Figure 7.25: Predicted SEL_{cum} impact footprint for the stationary fish (category 3) for percussive piling, with a soft start procedure and a bubble curtain, at the Western Wharf (Location 2)

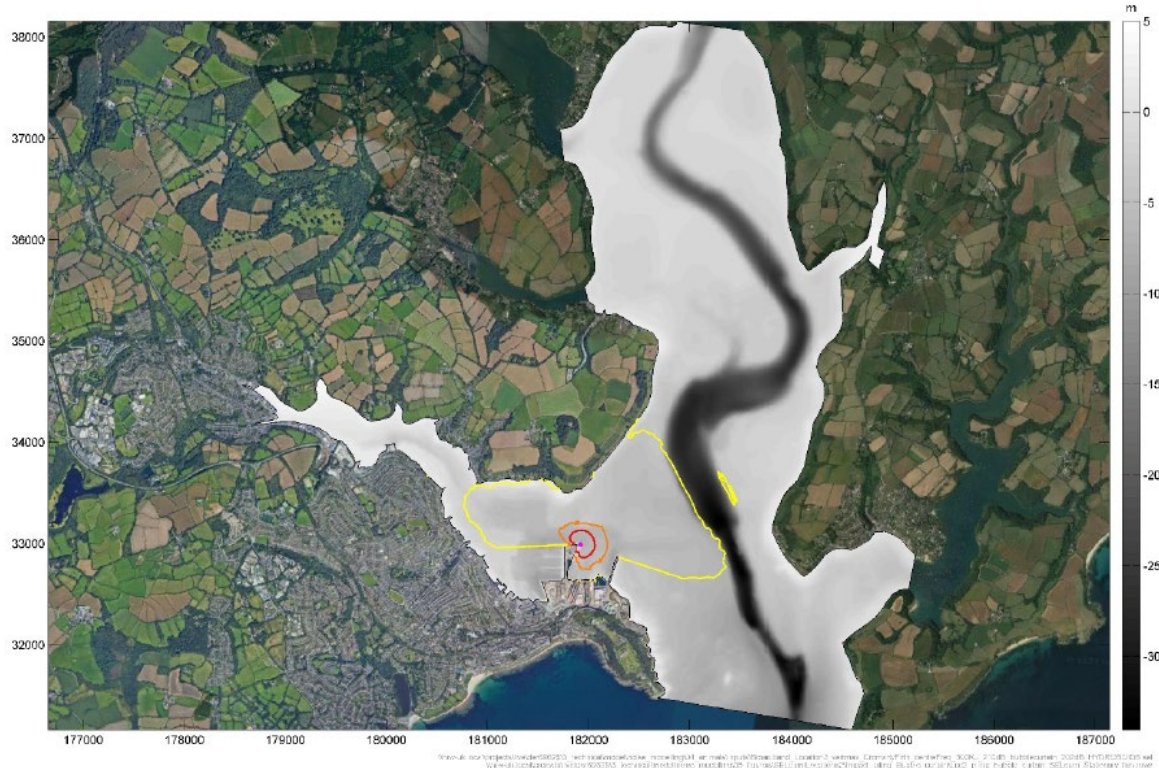
Design and placement of bubble curtain as mitigation, plus modelled evidence of reduction in sound attenuation across the estuary for category 2 hearing fish.

Tables below from the underwater noise technical annex are included that provide modelling output results for piling impact radii for both category 2 (highlighted yellow) and category 3 fish. The figure outputs are only provided for category 3 fish as a worst case. Results for stationary and fleeing fish are included, and with soft start only, as well as with bubble curtains as mitigation.

Note the following from the model outputs:

- For fleeing fish, with soft start only, impact footprint does not extend across the Carrick Roads channel (see Figure 7.18).
- For stationary fish, with soft start only, only the impact footprint for TTS extends across the Carrick Roads channel (see Figure 7.20).
- With bubble curtain, the modelling shows a reduced impact footprint, including reduced TTS and impact footprint does not extend across the Carricks Roads channel.
- Please note previous communications around the practicalities of bubble curtains, so if this is included in condition wording, we'd welcome wording to be included around their use such as 'reasonably practical', or something along those lines.
